Subject: *Roseboro Emergency Services Building - Sampson County
Addendum No. 3
Bid Question Response to RFB Issued 06/19/2026*

On behalf of our client, Sampson County (County), Kimley-Horn and Associates, Inc. is providing Addendum No. 3, dated 06/19/2026 in reference to the above-mentioned project. The following has been is attached for reference.

A1 DIMENSIONED FLOOR PLAN
SCALE: 1/4" = 1'-0"

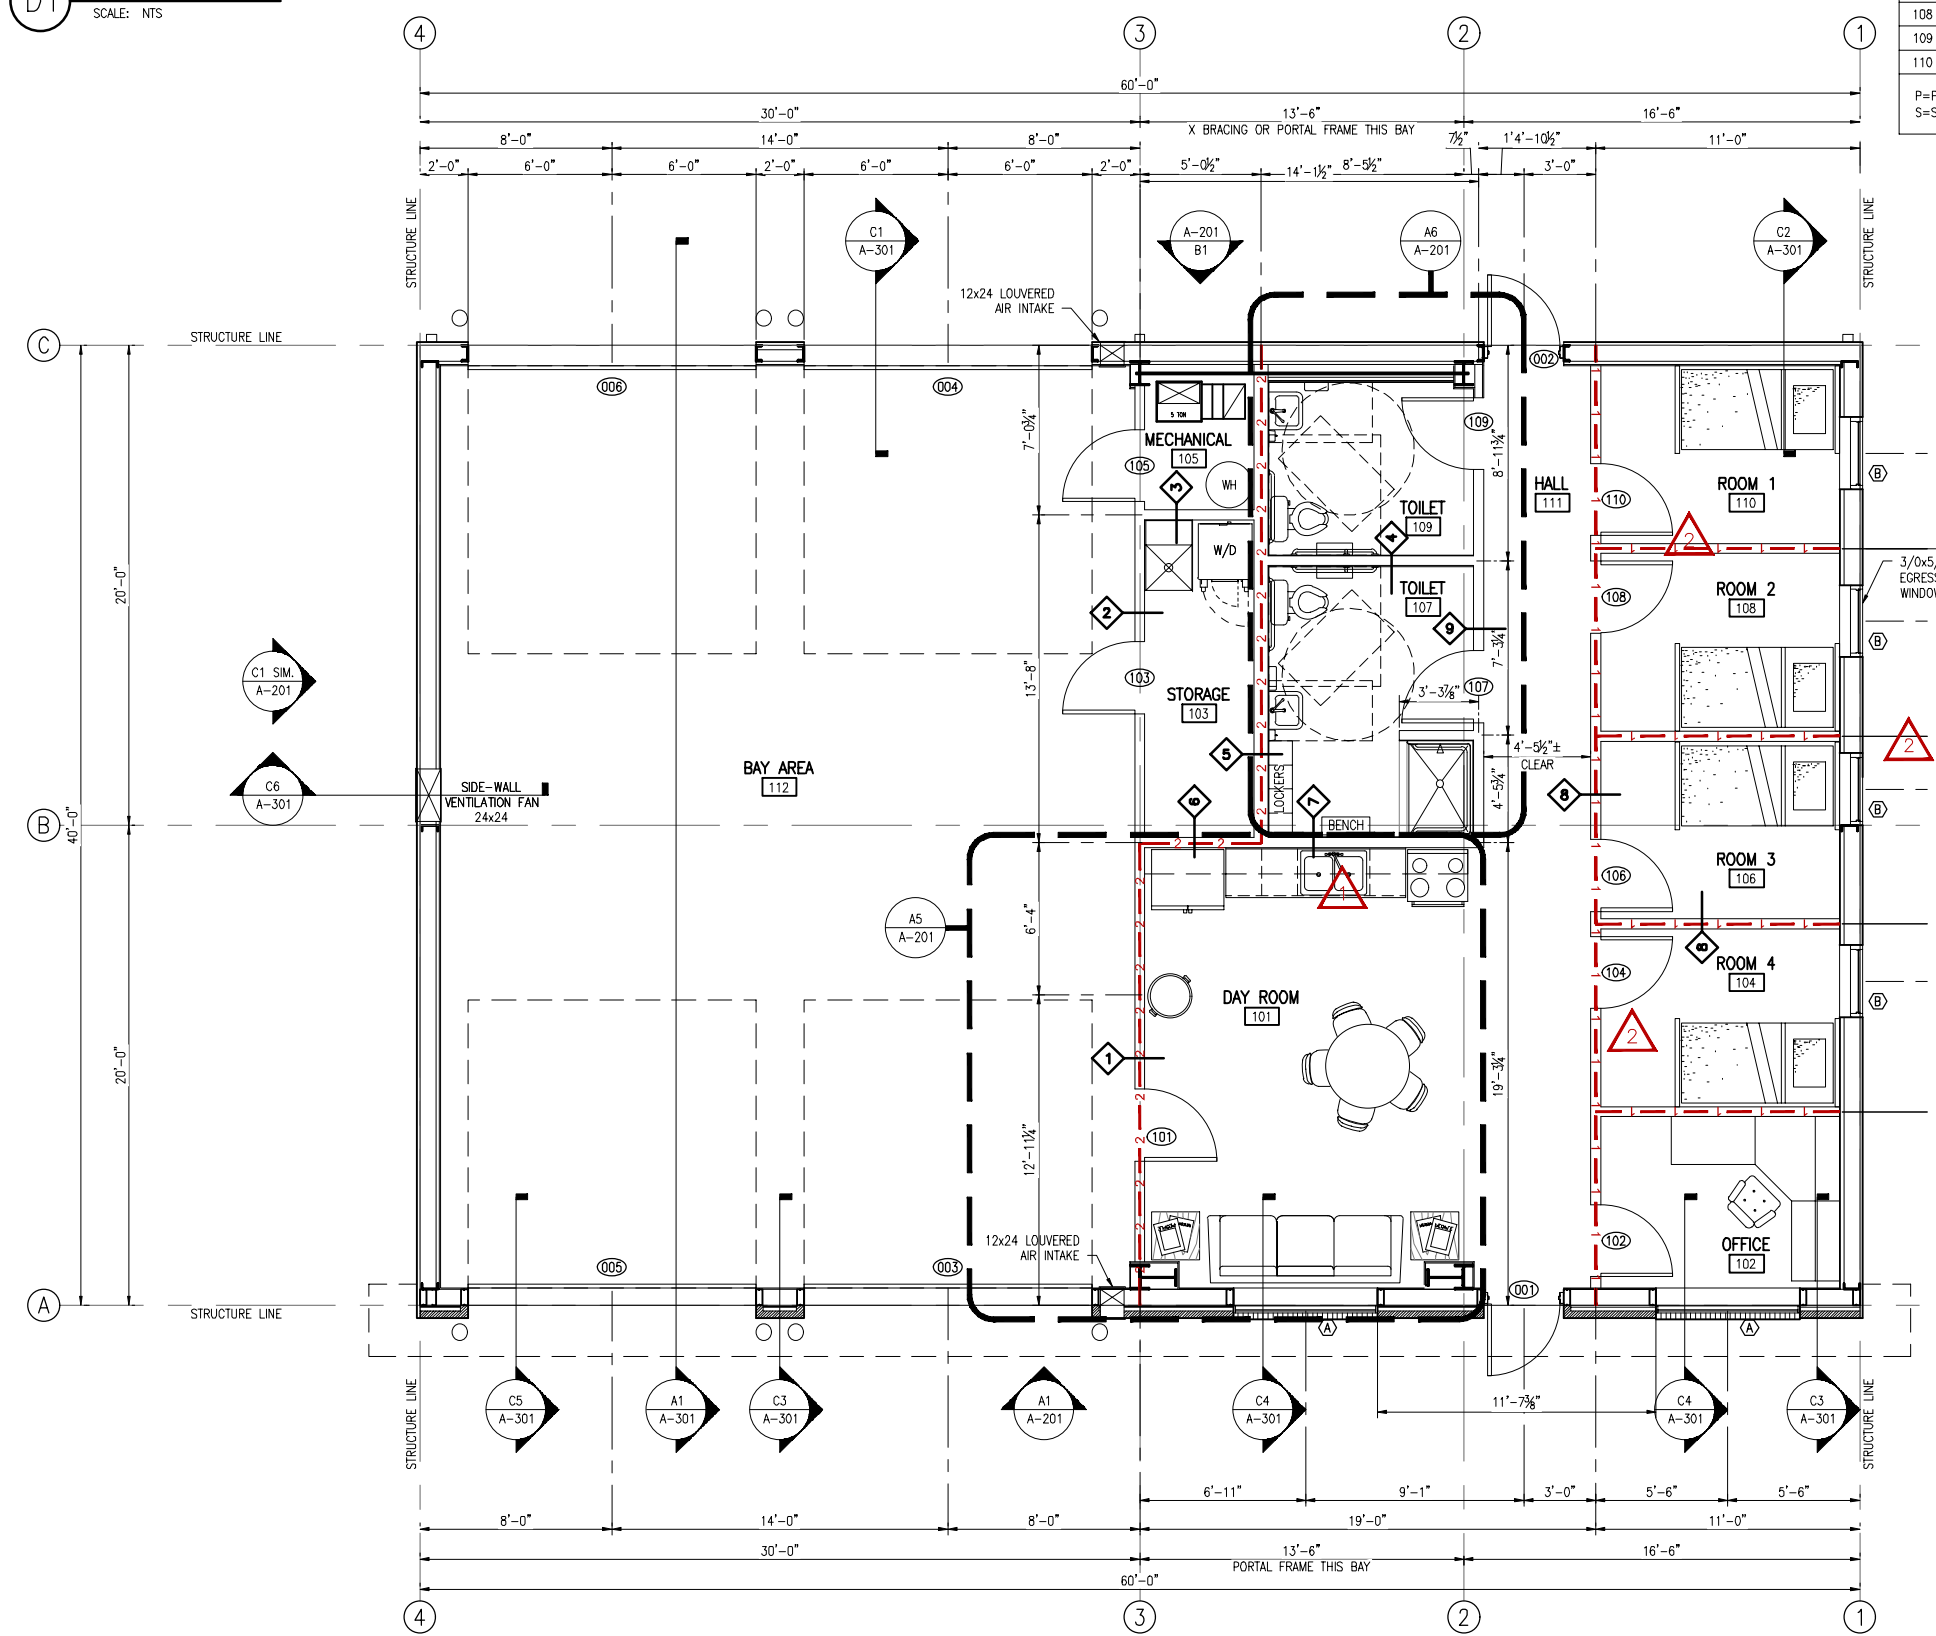
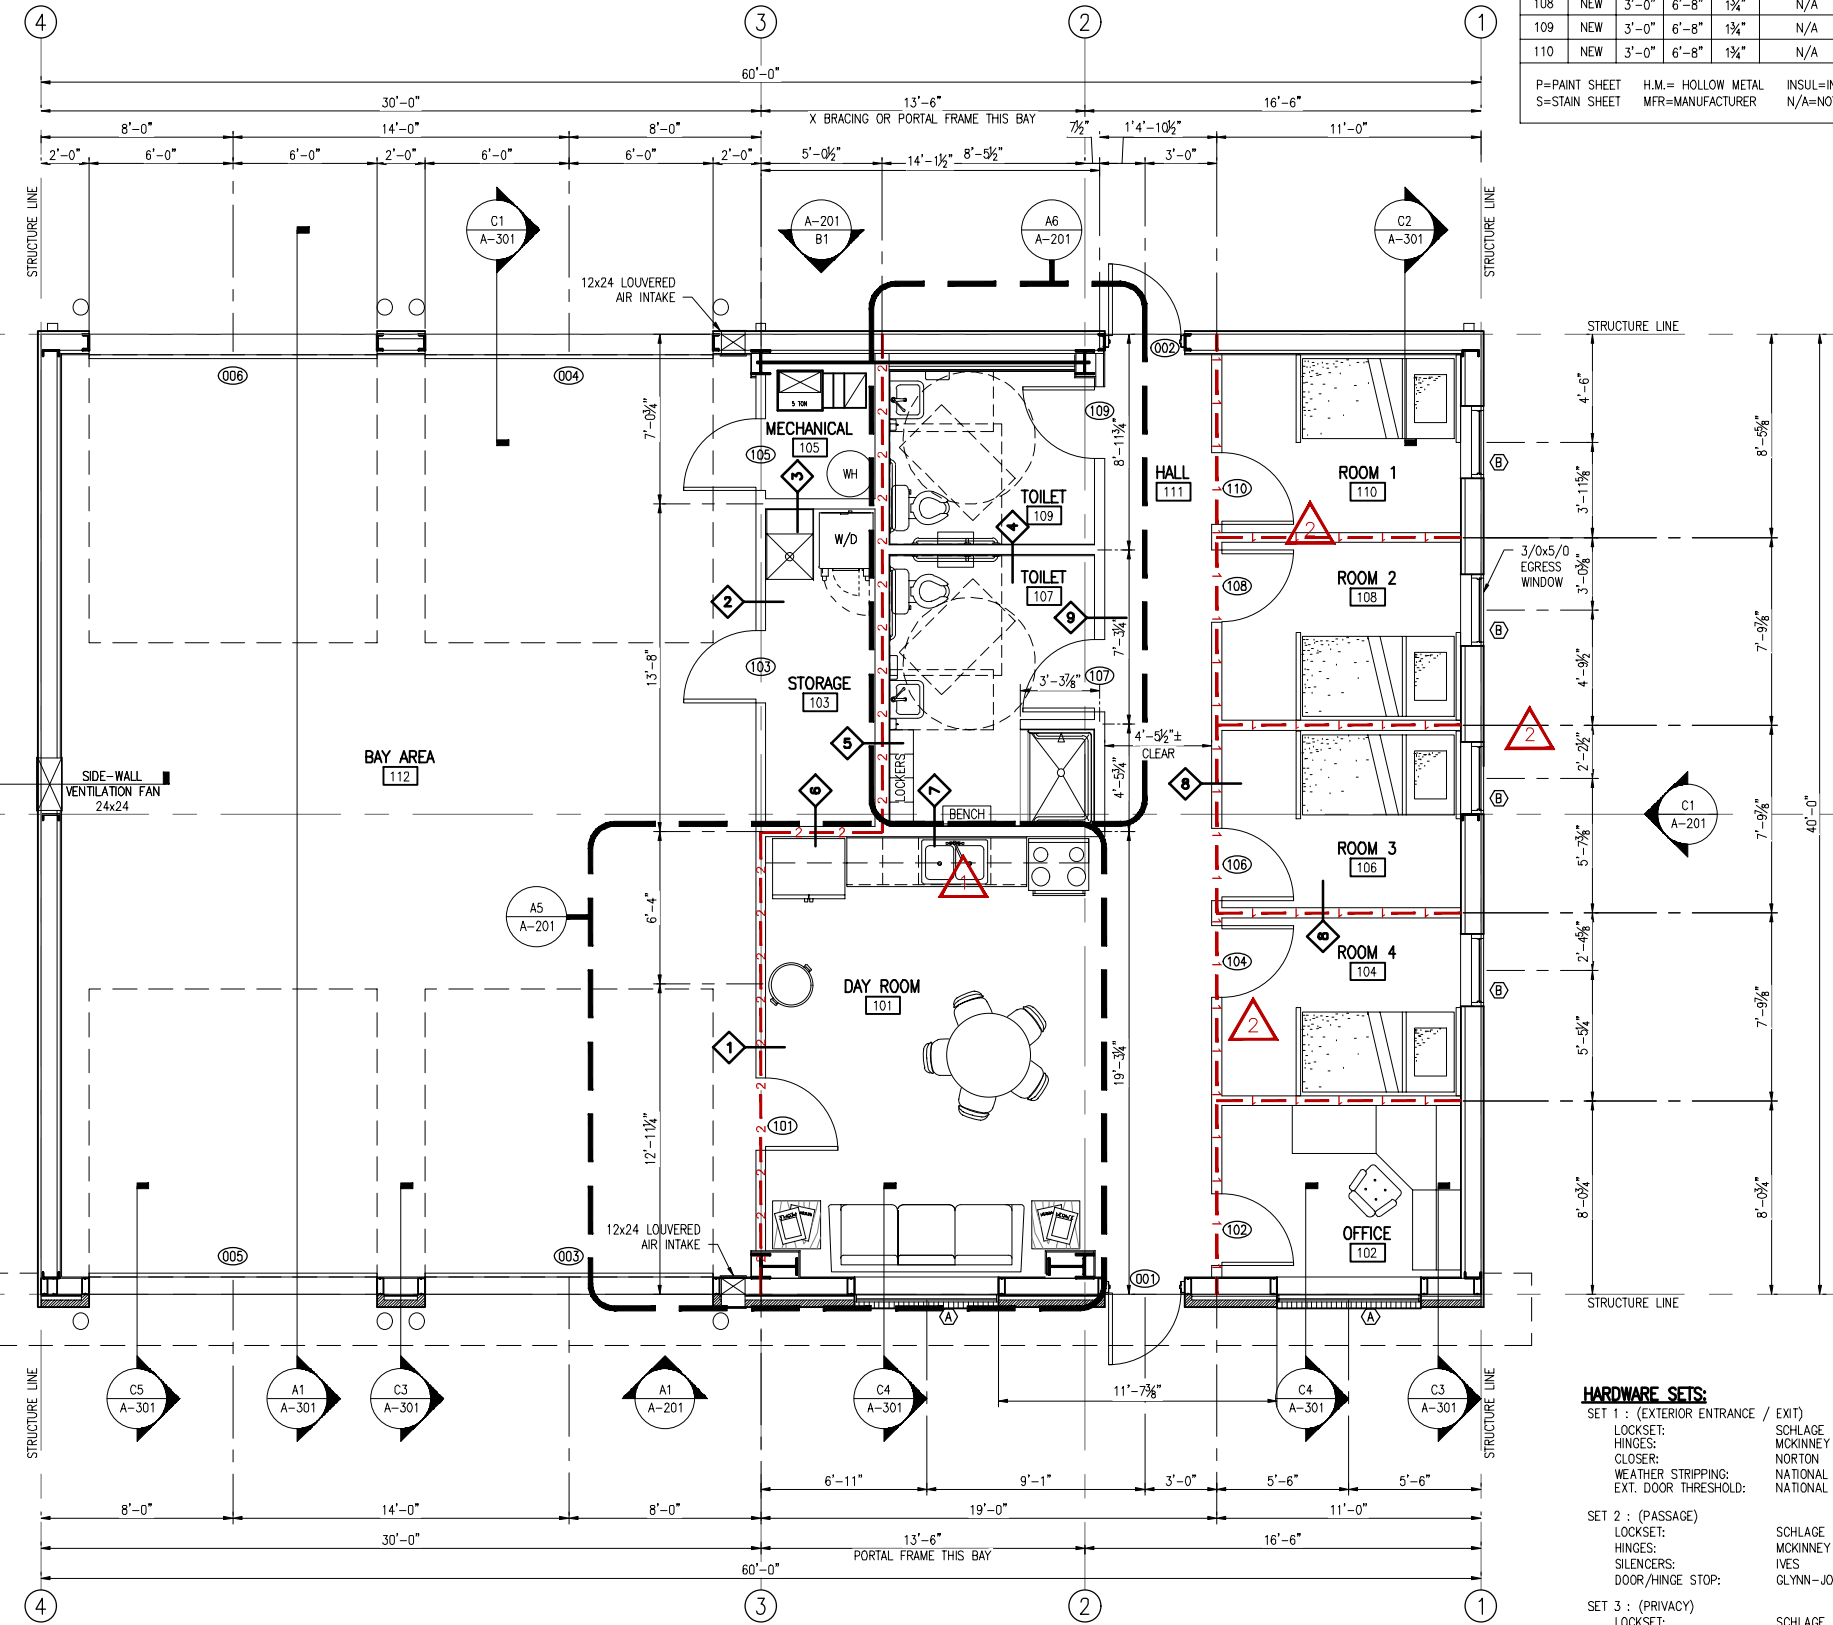
18. A-101 References C3/A-301 Wall Detail for the Bay Area. Is the intent to have drywall and lay in ceilings in the bay?

Response 18: Reference tag C3/A-103 in the truck bay should say "similar to". No ceiling in the truck bay but the wallboard does extend to the top track per the section. Also refer to Sheet A-102 for ceiling questions.
